MOUNT PEAKE PROJECT

ADDENDUM TO THE DRAFT ENVIRONMENTAL IMPACT STATEMENT

Wilora, Northern Territory

Animal Plant Mineral Pty Ltd

Figure 4-1: Mount Peake Project Regional Hydrology

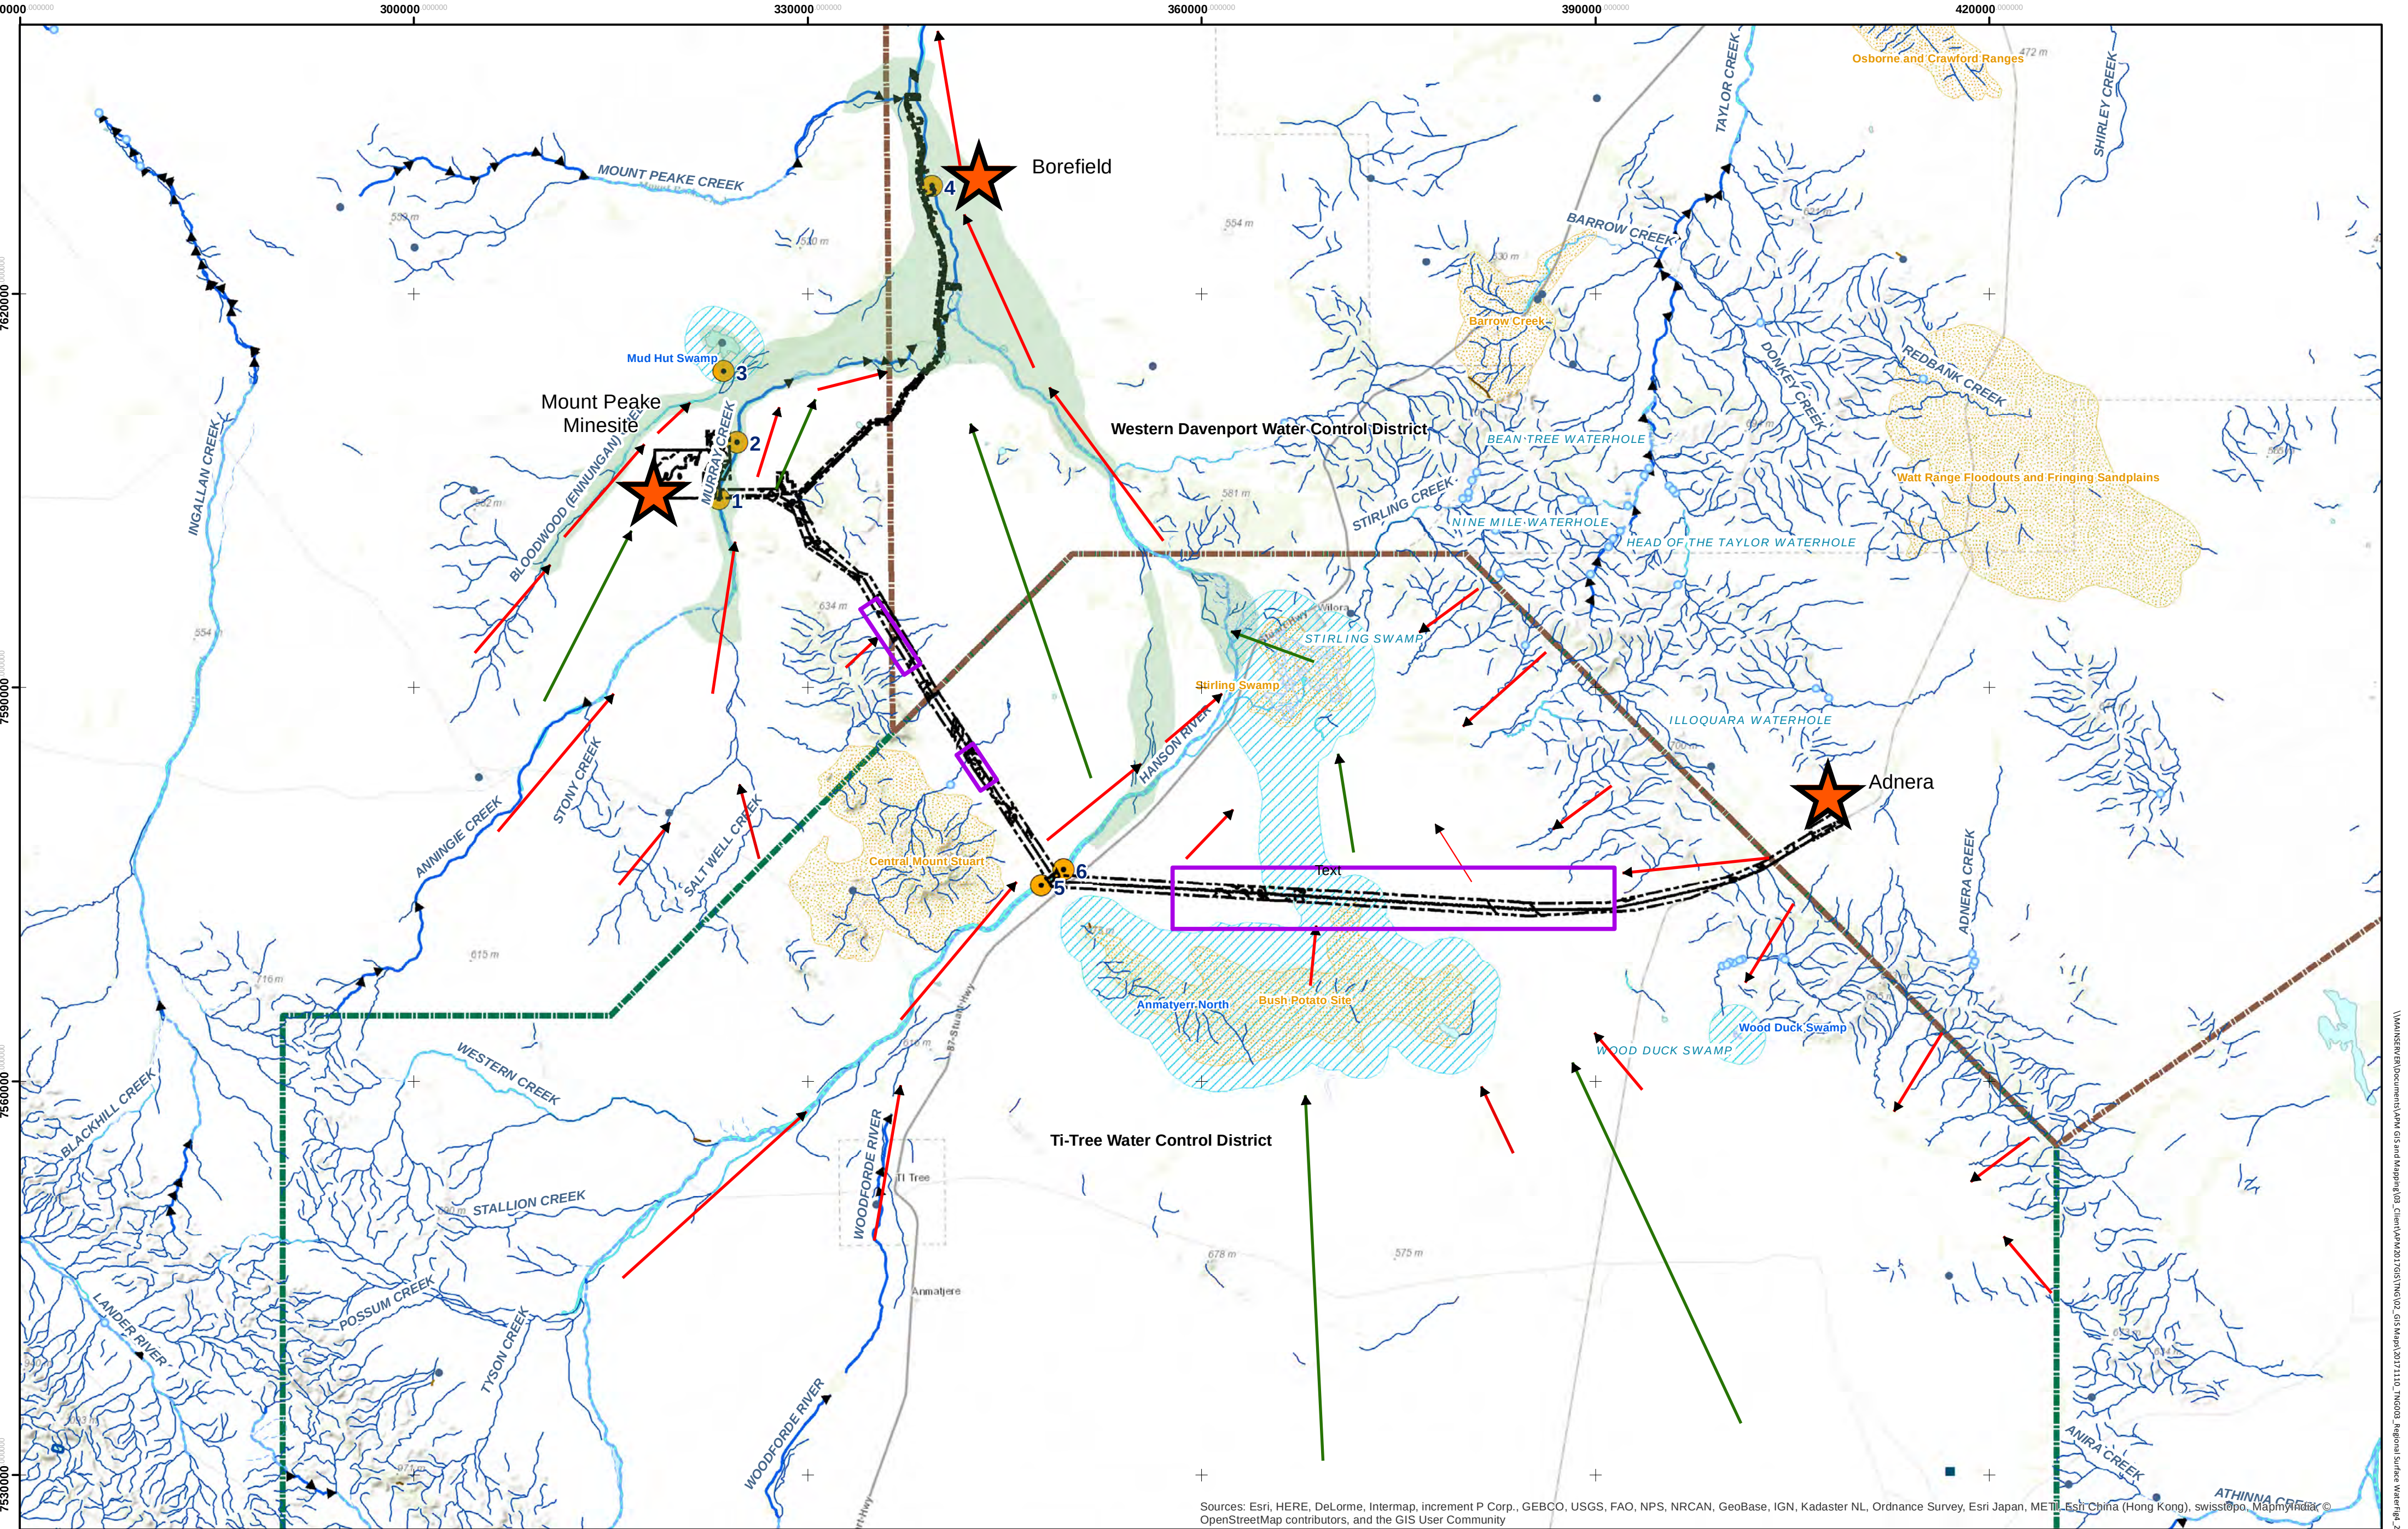
- The Draft EIS requested a plan showing the proximity of Project infrastructure to water features and flow directions, including both surface water and groundwater and their interaction. This was not sufficiently provided in the Supplementary Document.

A regional hydrological plan has been produced to clearly represent features requested by the NTEPA and appears as Figure 4-1. The Project areas appear in black and includes the mine site, borefield, haul/access road and the Adnera loadout facility.
